INDIANA DEPARTMENT OF TRANSPORTATION

STANDARDS COMMITTEE MEETING MINUTES

RE: Minutes for the February 16, 2006 Standards Committee Meeting

INDIANA DEPARTMENT OF TRANSPORTATION	
PUBLIC ROAD APPROACH TYPE C - GENERAL NOTES	
STANDARD DRAWING NO. E 610-PRAP-08	
<div style="display: flex; justify-content: space-between;"> <div>  </div> <div>  </div> </div>

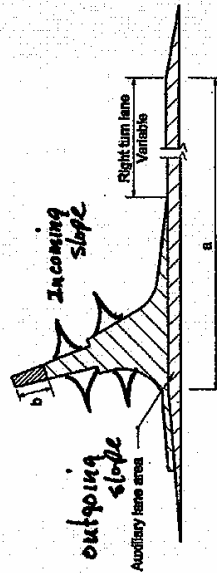
These notes are for Standard Drawings
E 610-PRAP-08 and E 610-PRAP-09.

See table on Standard Drawing
E 610-PRAP-04 for

- 1) Embankment slopes built on either side of the approach within the mainline clearance shall be constructed for functional classification of the public road as follows:

2. Cross culverts under the public road approach which cannot be located outside the mainline clear zone will require appropriate end treatments at each end as shown on the plans.

CAST-IN-PLACE CONCRETE RETAINING WALL EARTHWORK QUANTITIES LIMITS
Figure 05-25A

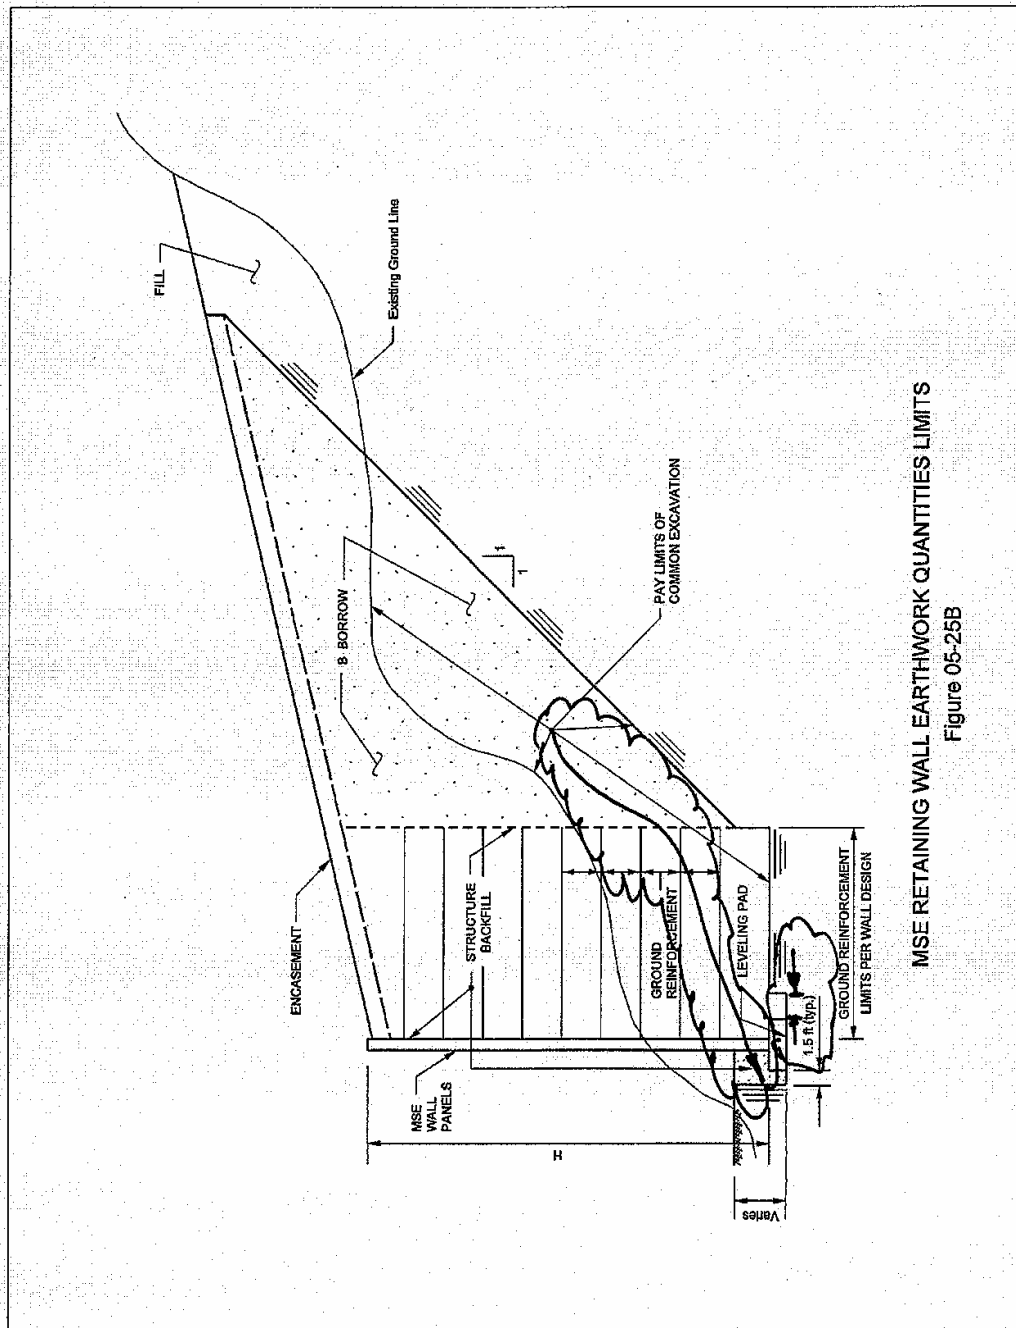
Figure 05-25A, Cast-in-Place Concrete Retaining Wall Earthwork
Quantities Limits.

These figures along with the corresponding metric versions are being revised to reflect
the limits of excavation.

MSE RETAINING WALL EARTHWORK QUANTITIES LIMITS
Figure 05-25B

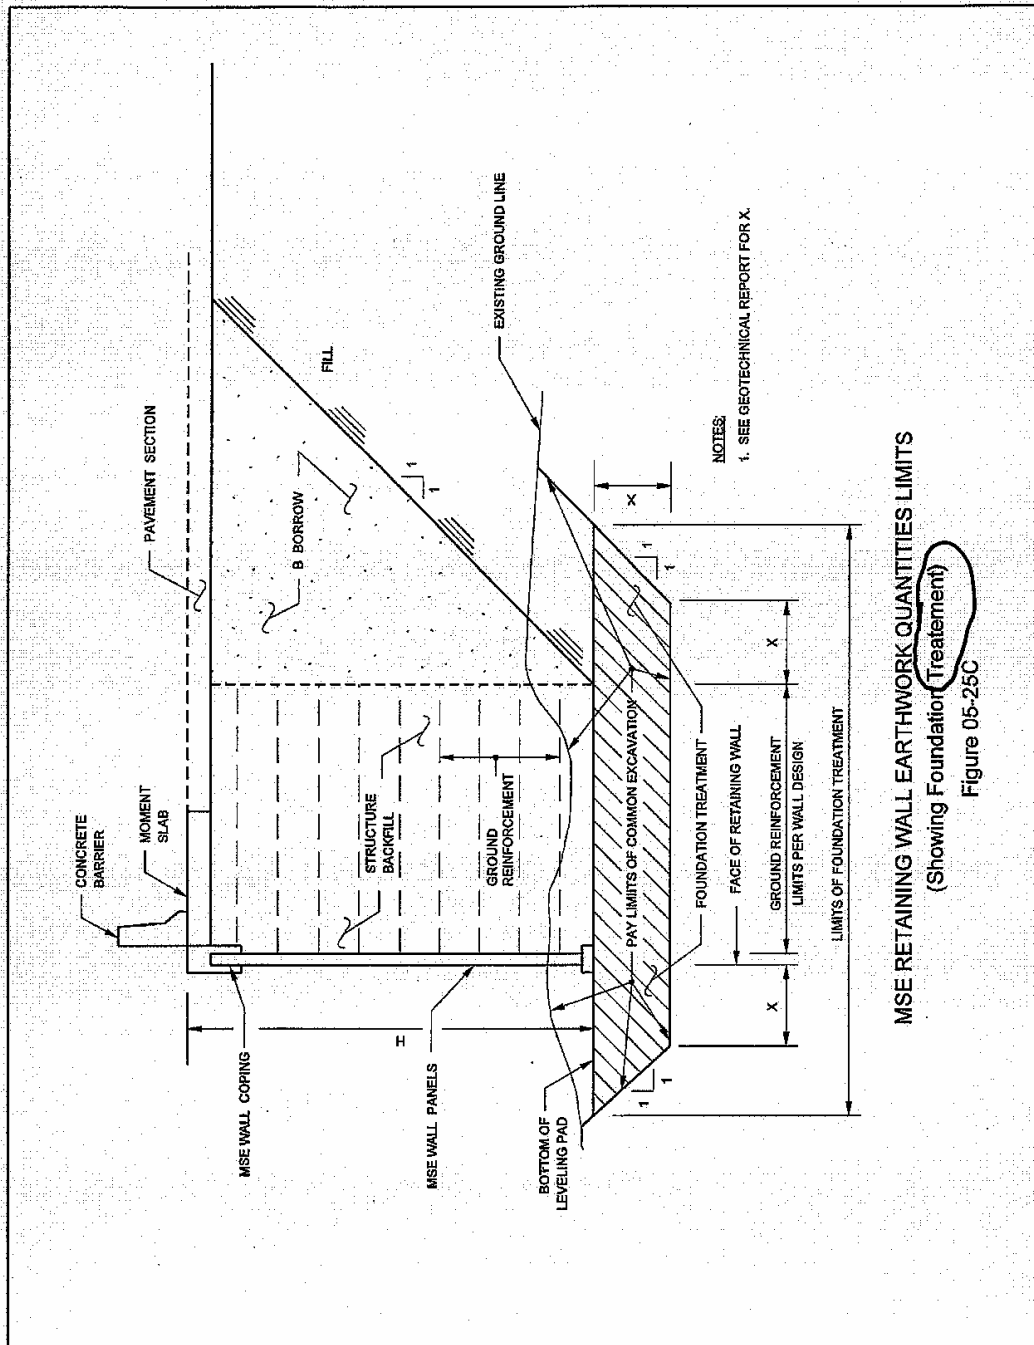
Figure 05-25B, MSE Retaining Wall Earthwork quantities Limits.

MSE RETAINING WALL EARTHWORK QUANTITIES LIMITS
(Showing Foundation Treatment)
Figure 05-25C

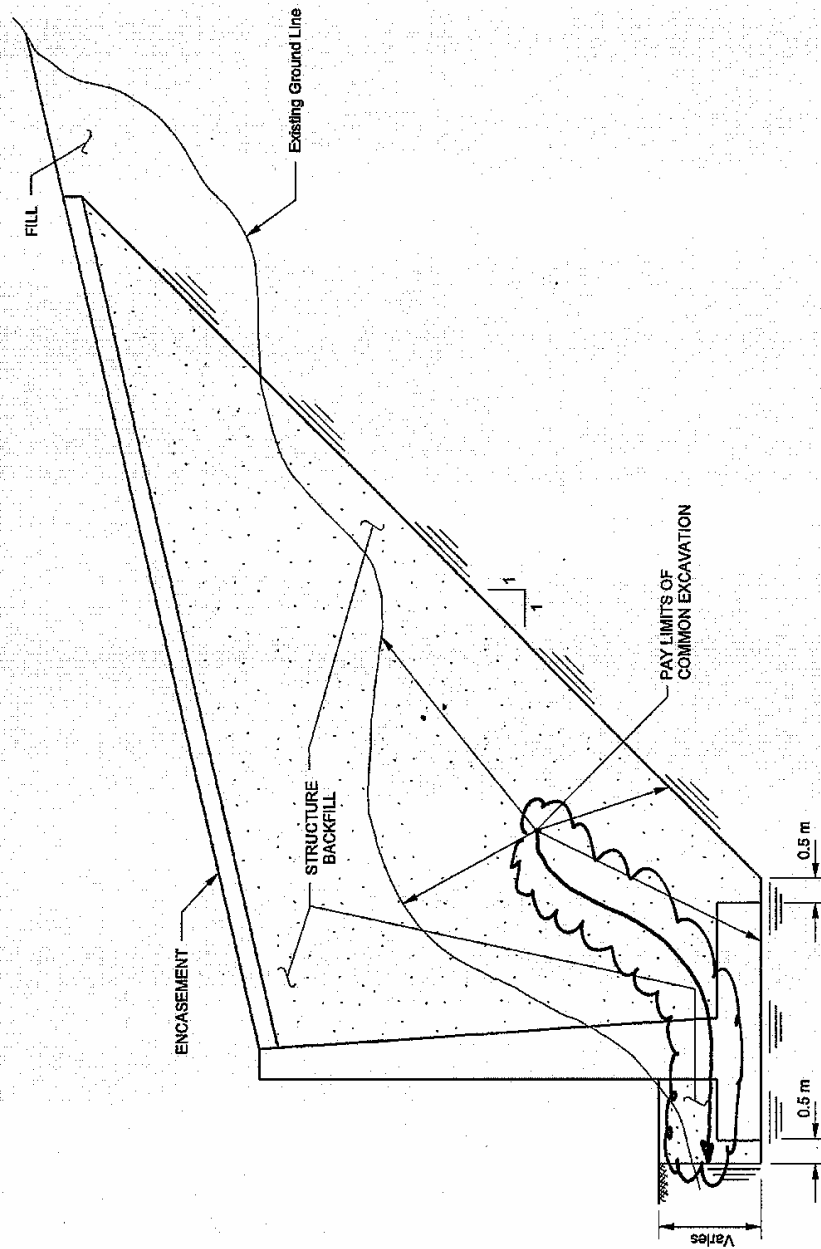
Figure 05-25C, MSE Retaining Wall Earthwork Quantities Limits.
